H. B. ROBINSON STEAM ELECTRIC PLANT, UNIT NO. 2
DOCKET NO. 50-261 / RENEWED LICENSE NO. DPR-23

Subject: Second Six-Month Status Report in Response to March 12, 2012 Commission Order Modifying Licenses With Regard to Requirements for Mitigation Strategies for Beyond-Design-Basis External Events (Order Number EA-12-049)

**SECOND SIX MONTH STATUS REPORT (ORDER EA-12-049)
H.B. ROBINSON STEAM ELECTRIC PLANT (RNP), UNIT 2**

Z08R2 M-2 G-190197-SH00001 Connection to CST

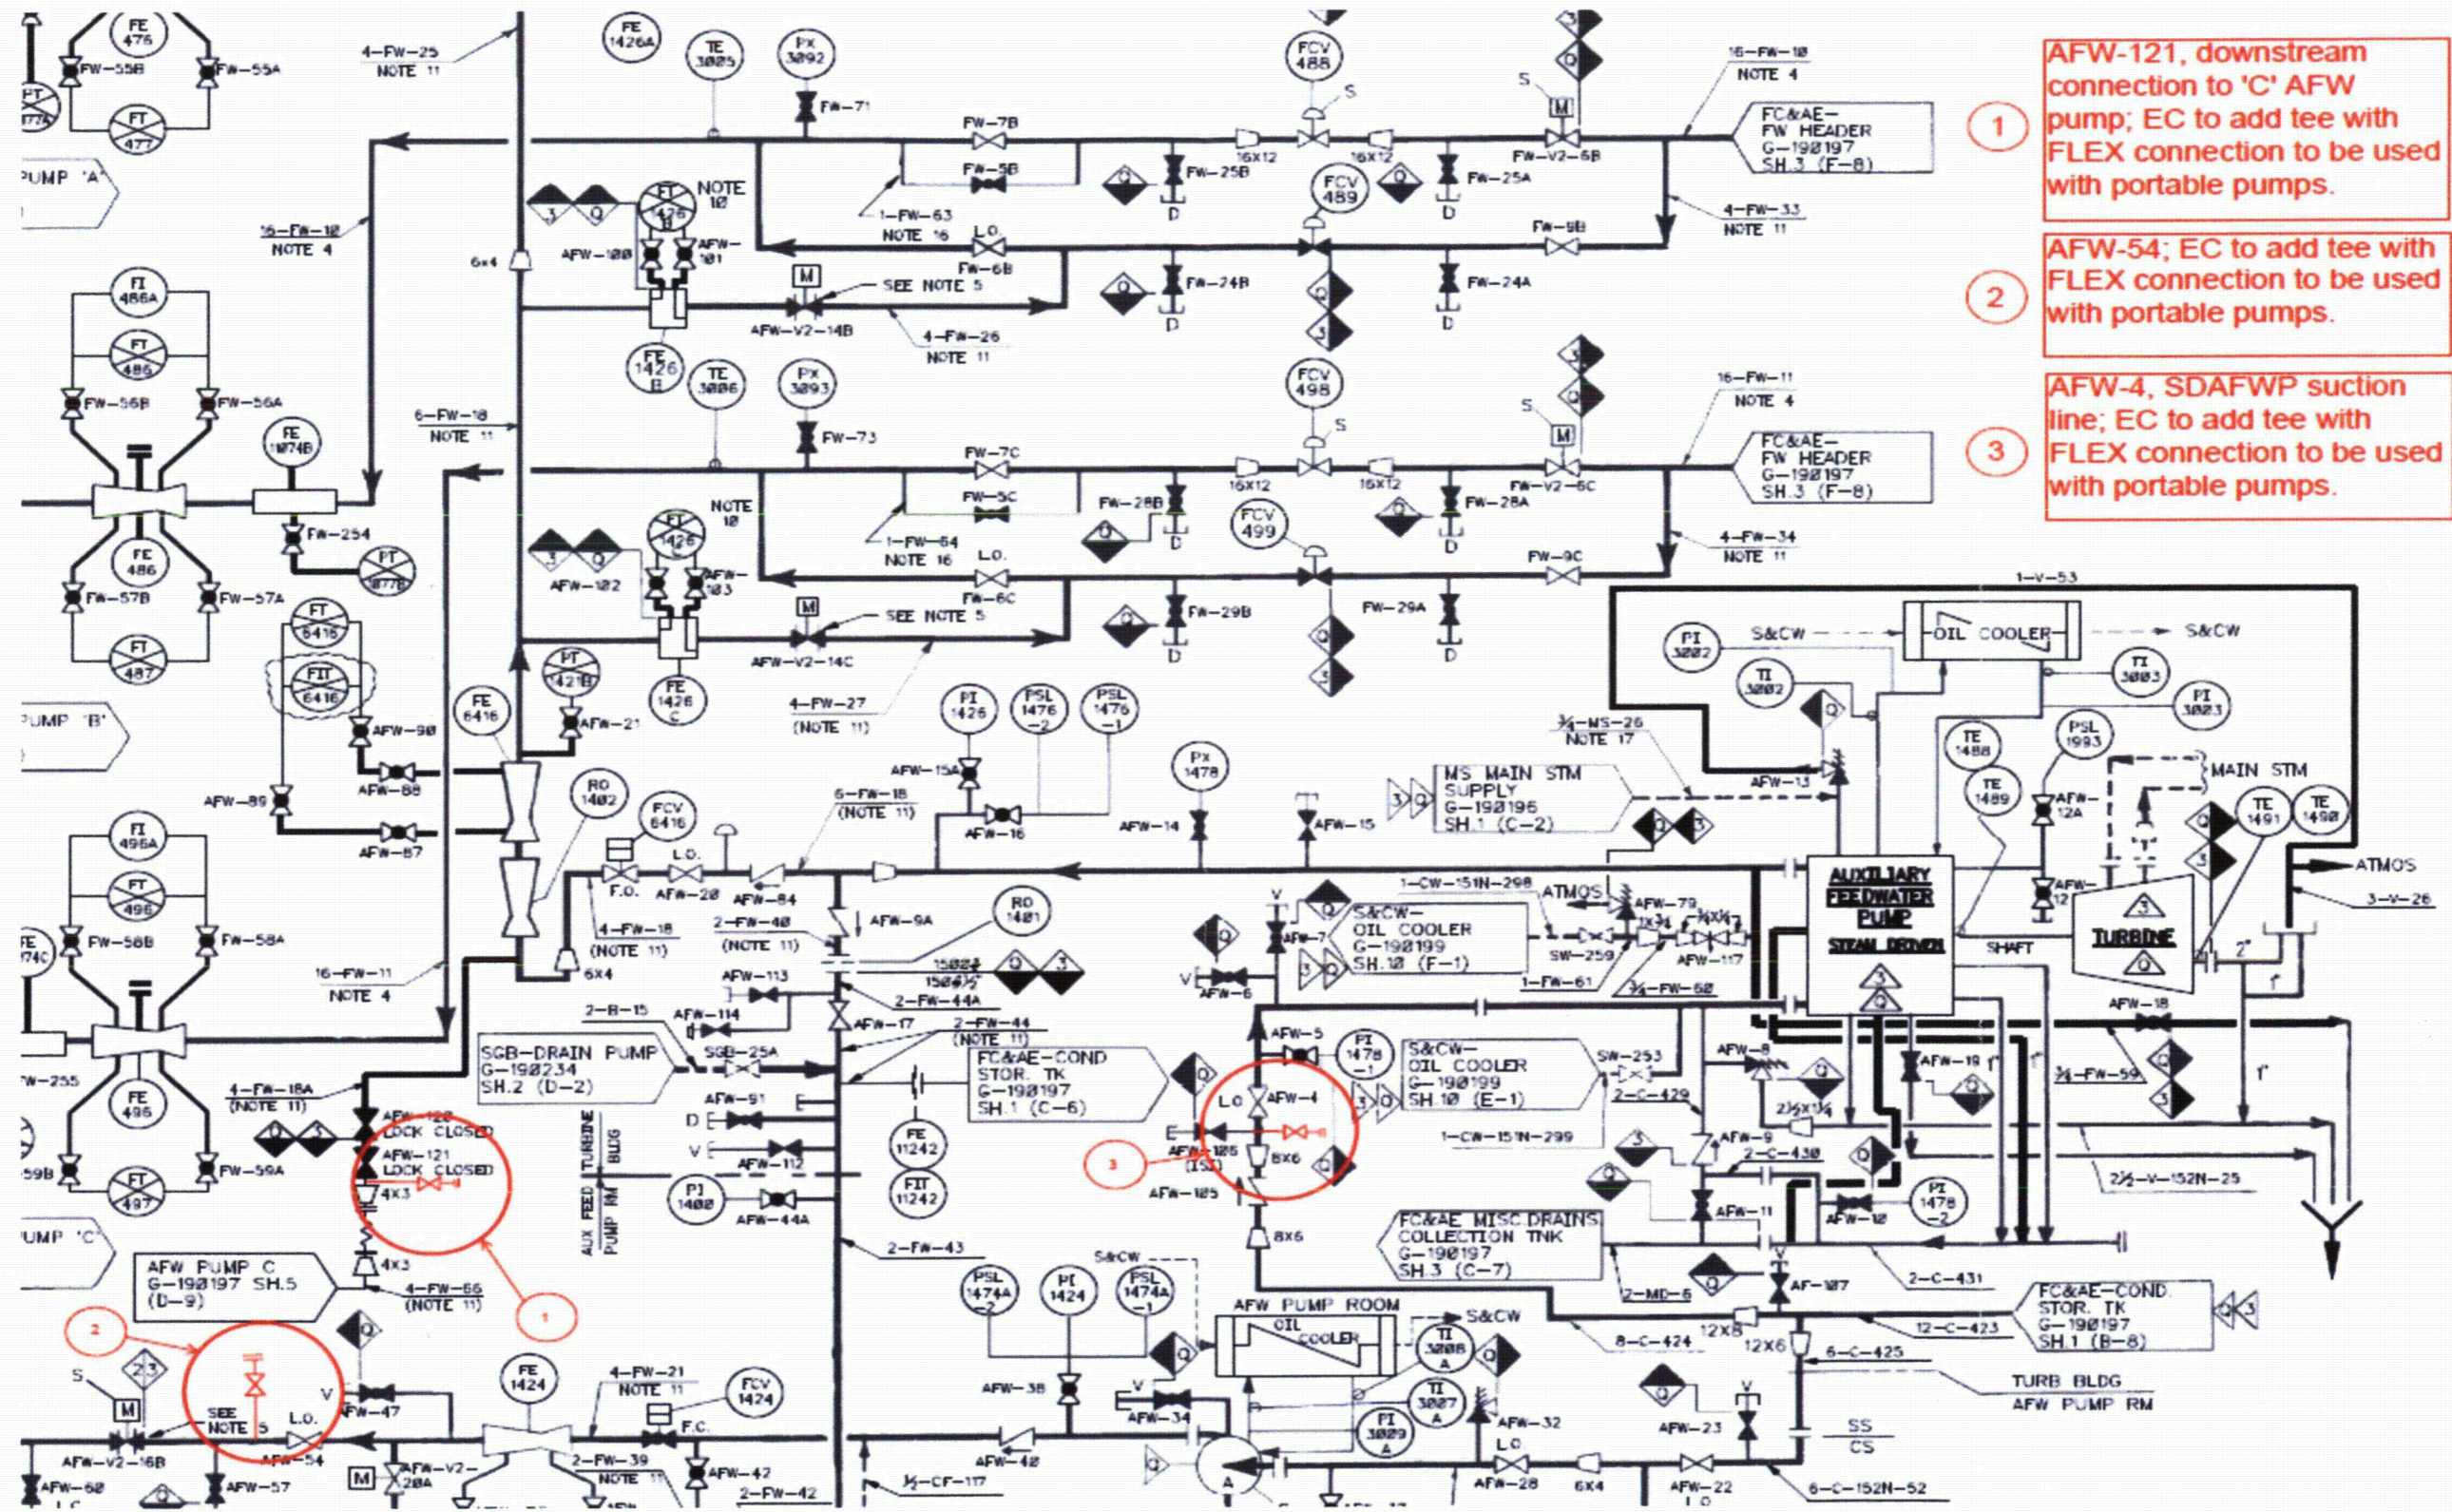
Makeup to the CST can be via the six inch emergency fill connection valve, DW-285, (which will be modified to accommodate a standard FLEX fitting), (Open Item 20).

In lieu of using DW-285, CST Emergency Fill Connection Valve, as the CST fill FLEX connection, CST-66, CST Drain Valve, will be used as the CST fill FLEX connection.

DW-285, CST Emergency Fill Connection Valve, was used as the tie-in point for the 4th train of AFW modification ('C' AFW Pump) and is not the best choice for this service.

Z09R2 M-3 G-190197-SH00004 Connections to C AFW pump, MDAFWP discharge FLEX Conn

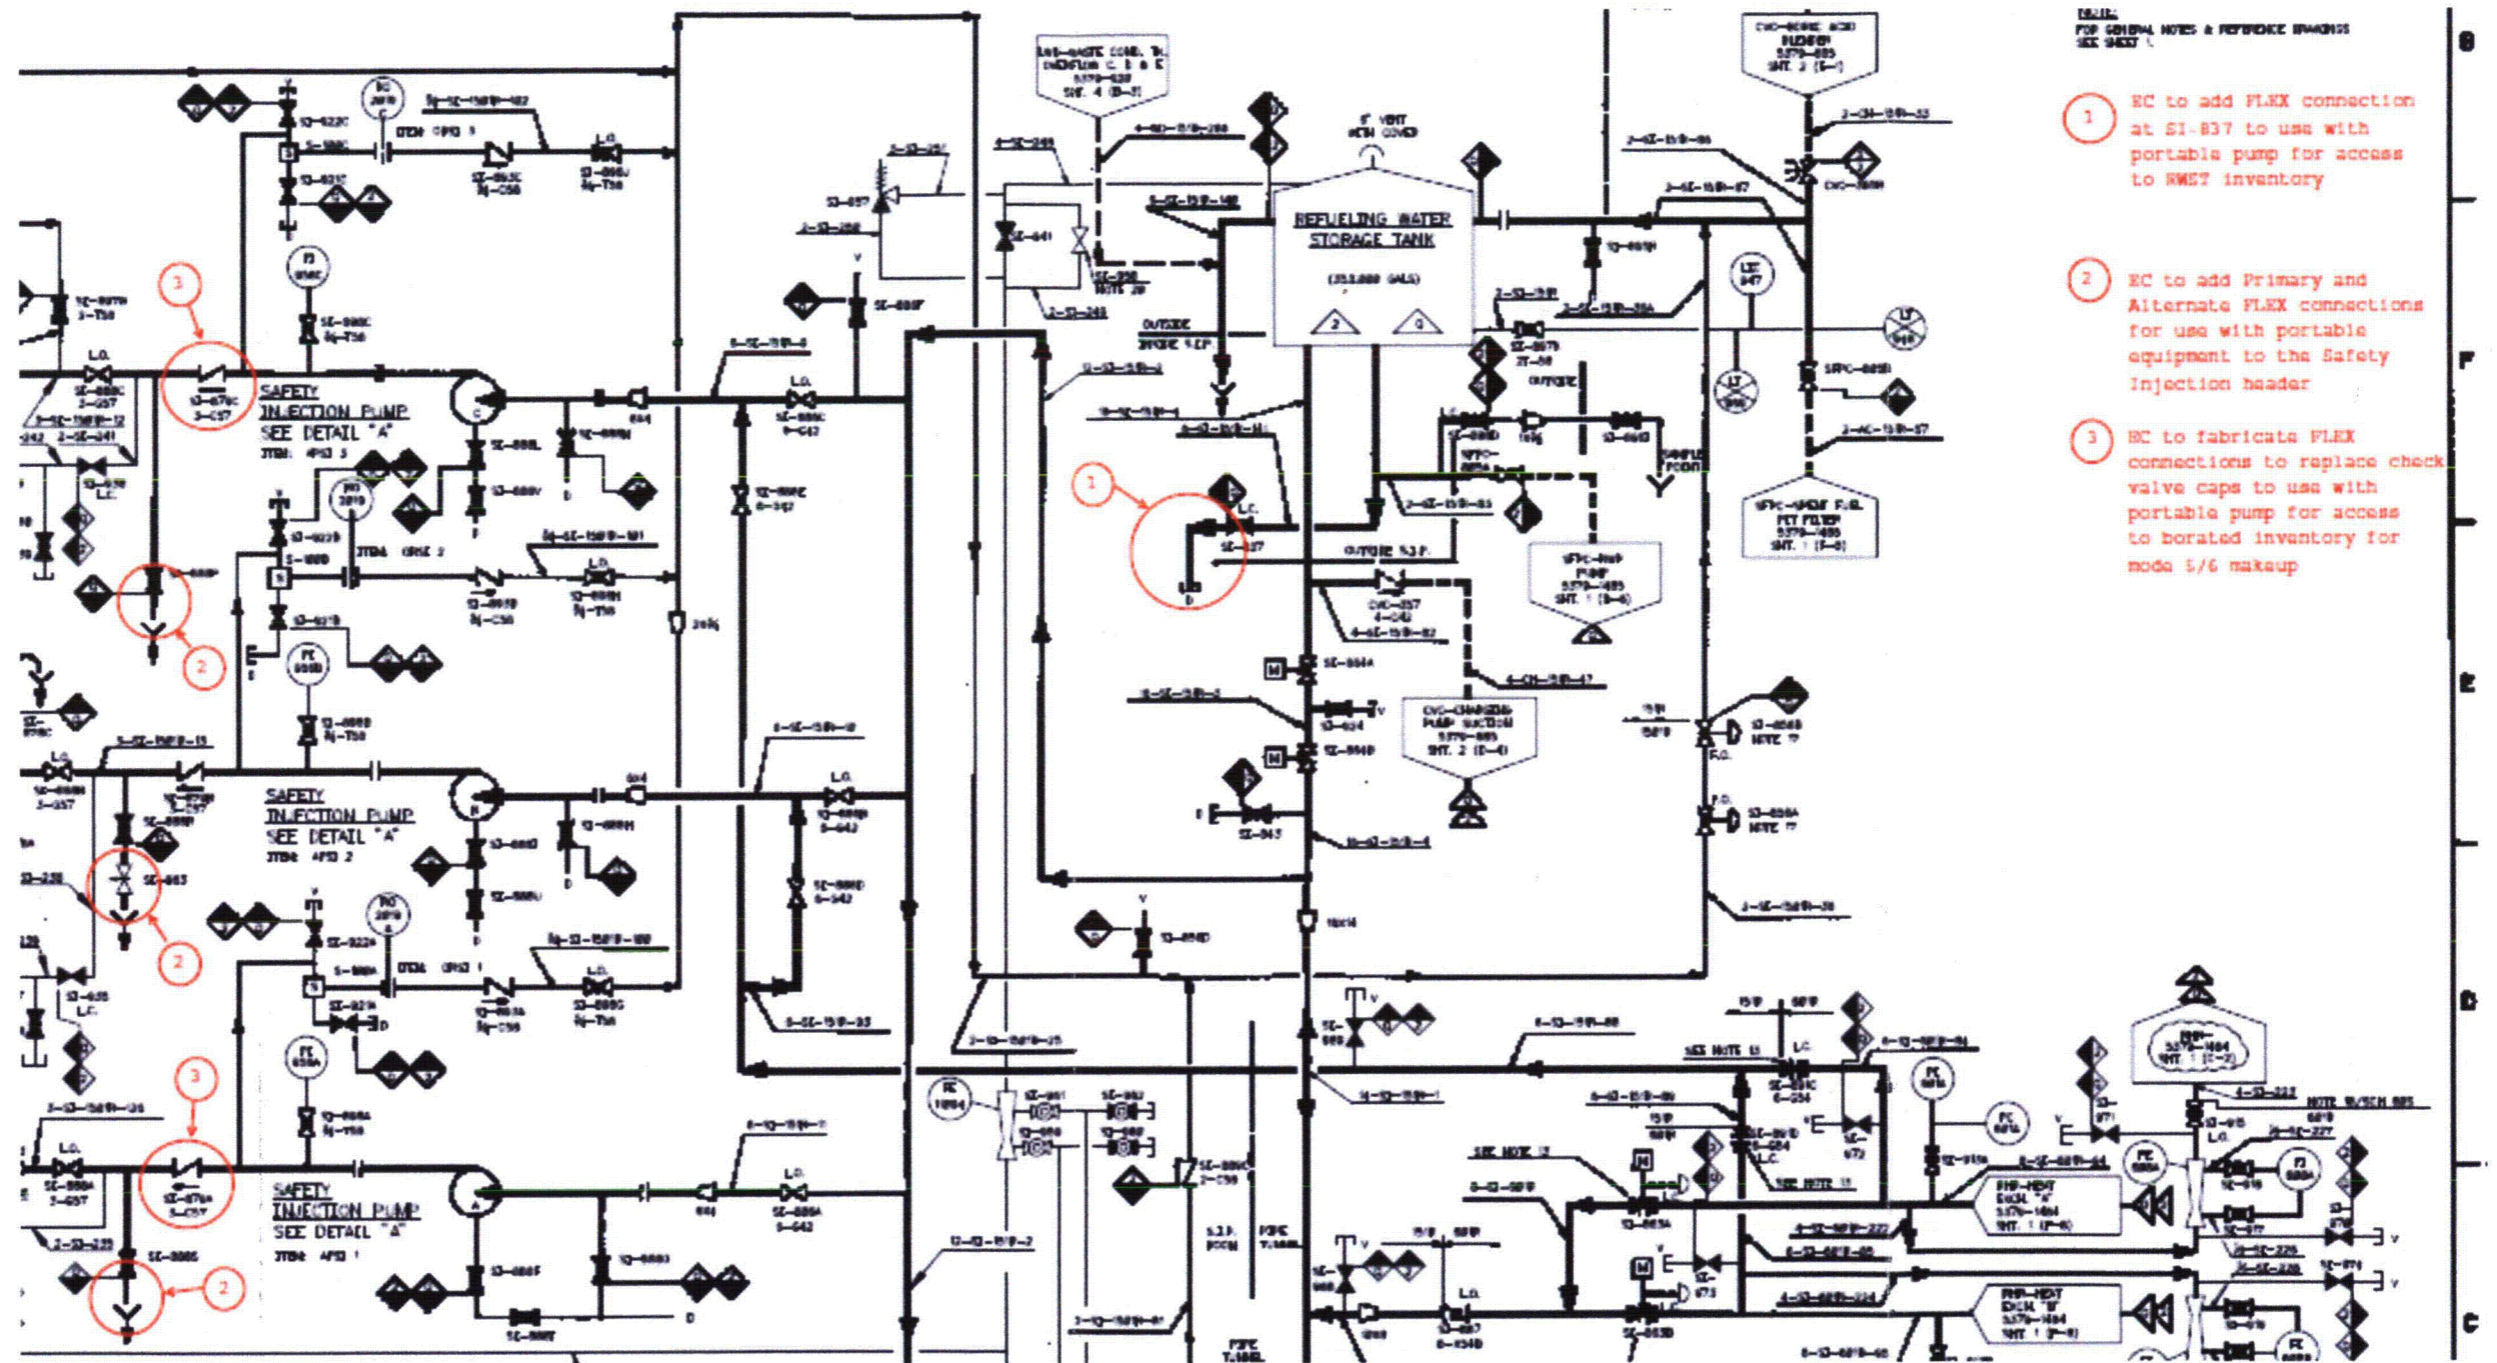
- 1 AFW-121, downstream connection to 'C' AFW pump; EC to add tee with FLEX connection to be used with portable pumps.
- 2 AFW-54; EC to add tee with FLEX connection to be used with portable pumps.
- 3 AFW-4, SDAFWP suction line; EC to add tee with FLEX connection to be used with portable pumps.

Z15R2 M-9 5379-01485 Emergency Cooling Connection to SFP

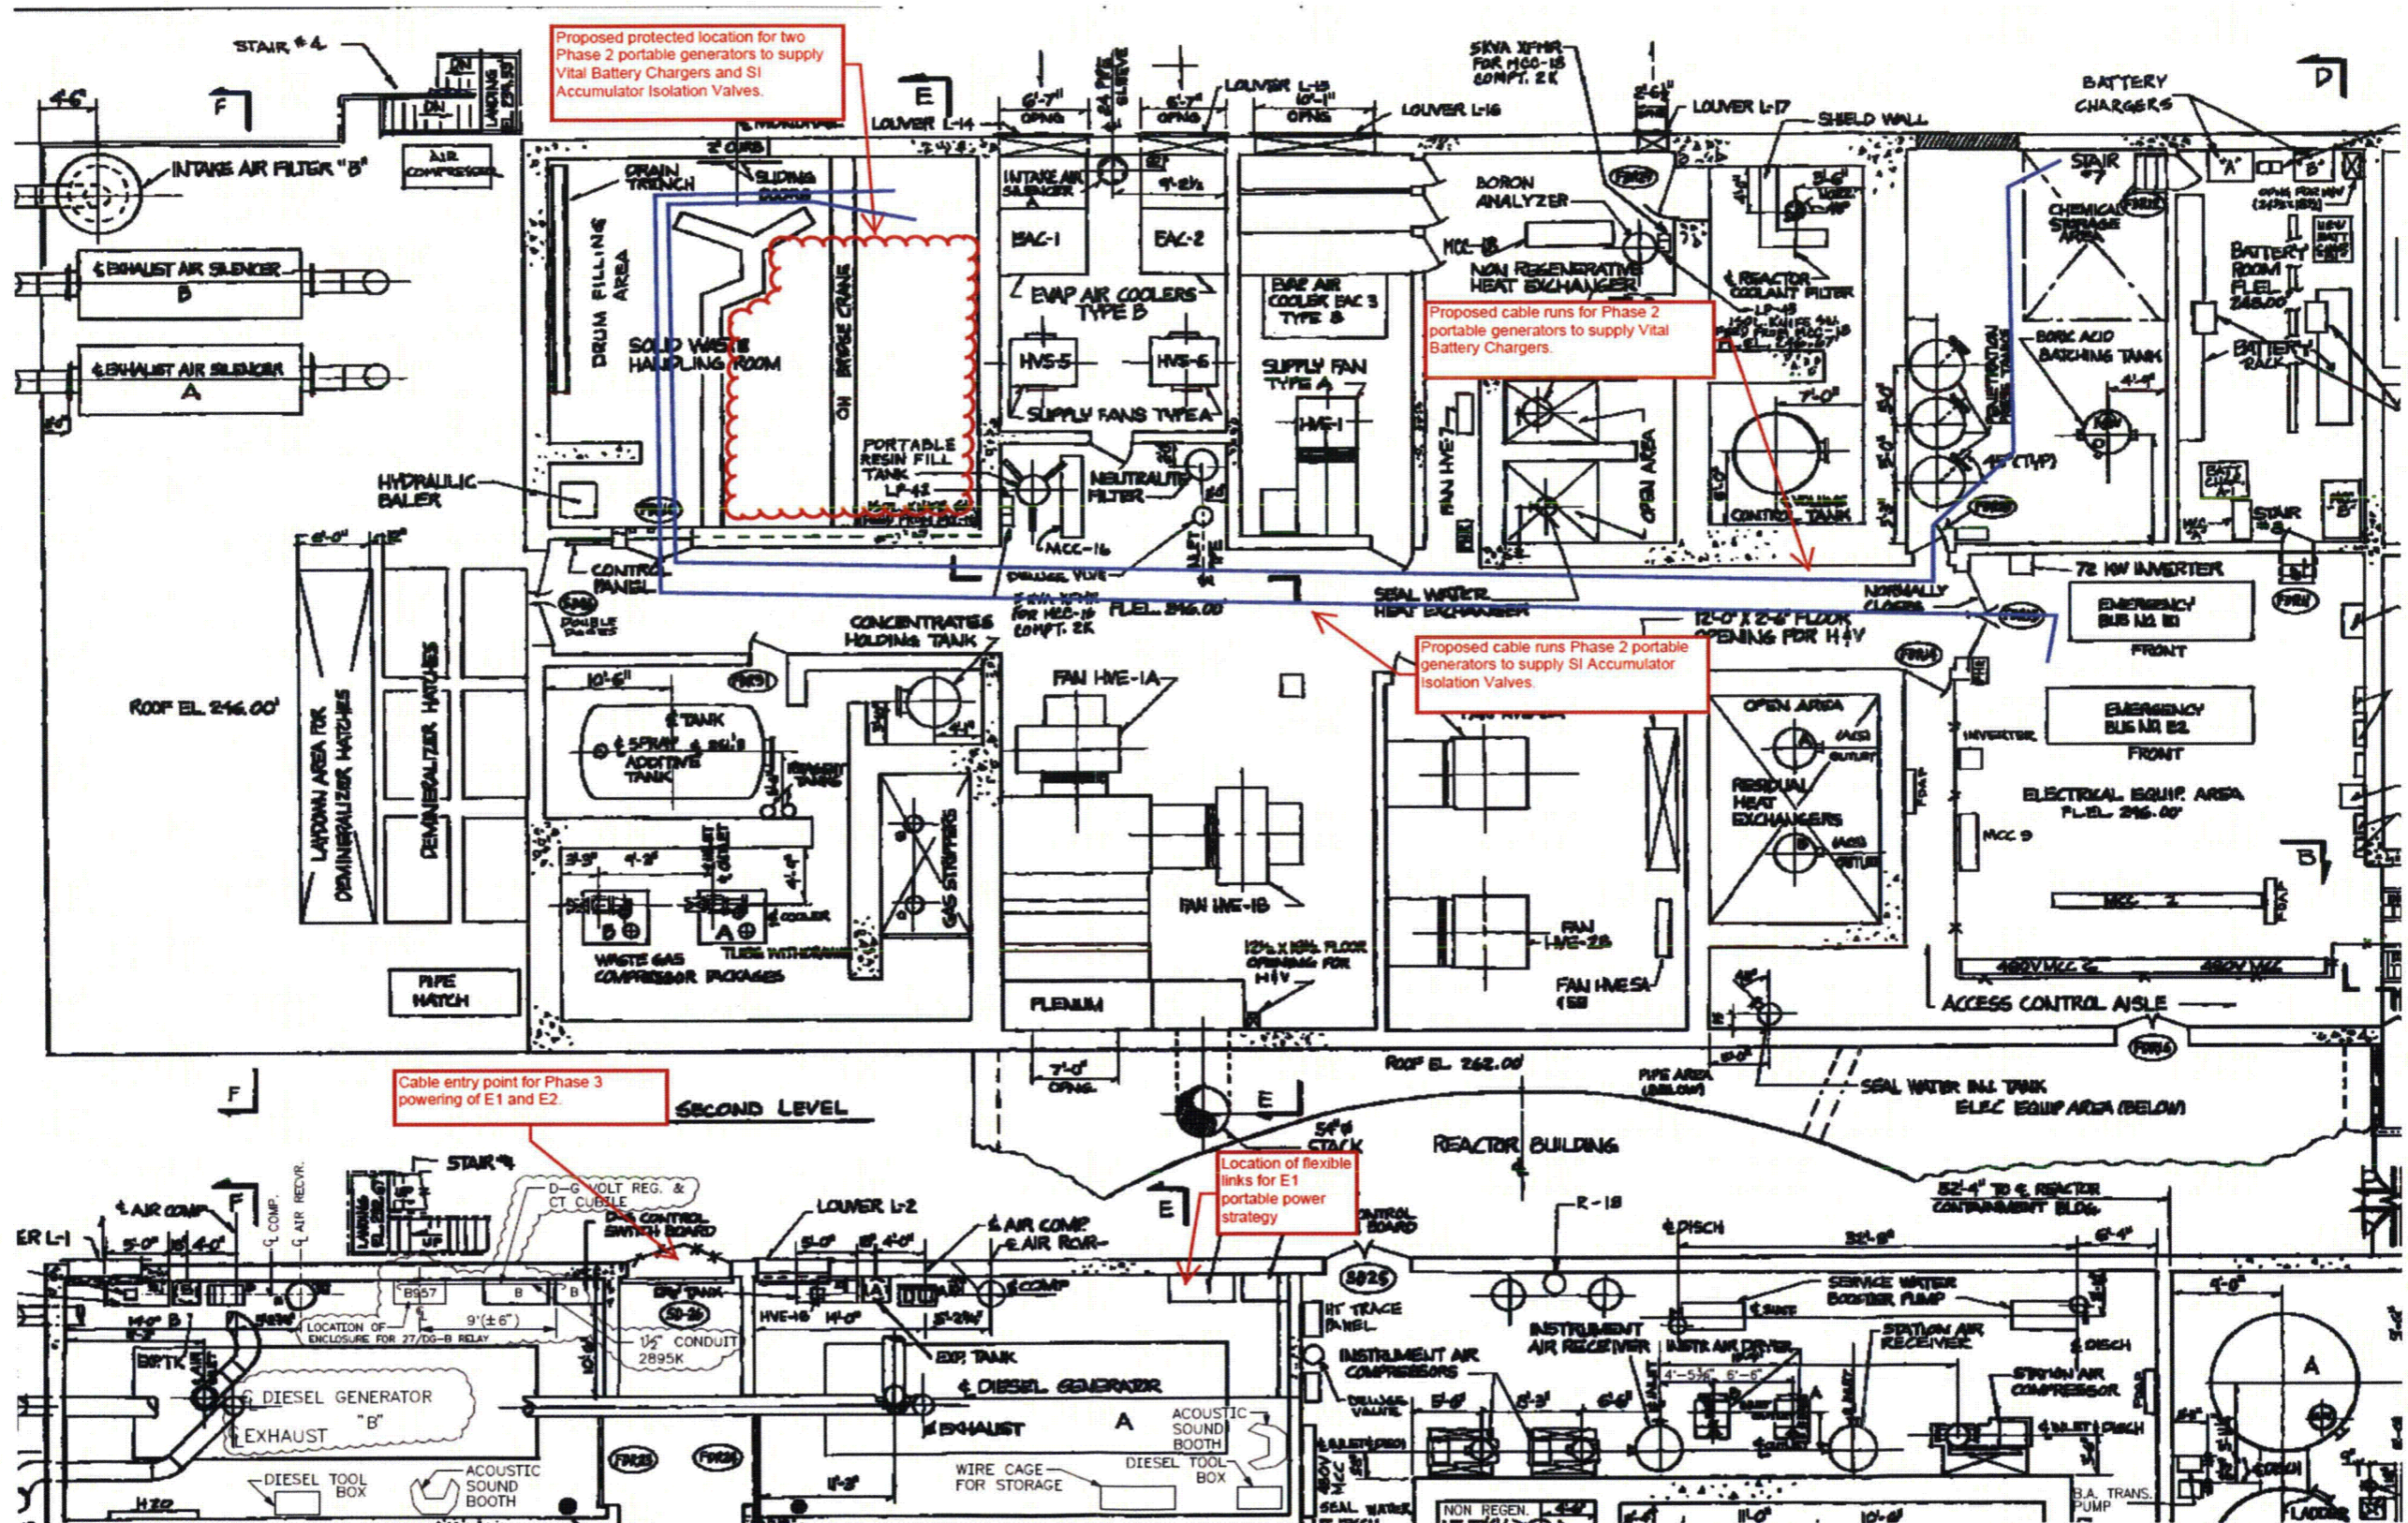
The OIP describes two Emergency Cooling Connections (ECC) in the SFP Cooling System that could be used for SFP fill using a portable pumper as an alternate strategy. Robinson will use one of the ECC connections upstream of the SFPC Heat Exchanger at valve SFP-742. This meets the requirements of NEI 12-06.

① Emergency Cooling Connection to SFP (1st floor Aux. Building - preferred location due to ease of access); BC to add FLEX Connection for external SFP makeup via robust, installed piping and portable pumps.
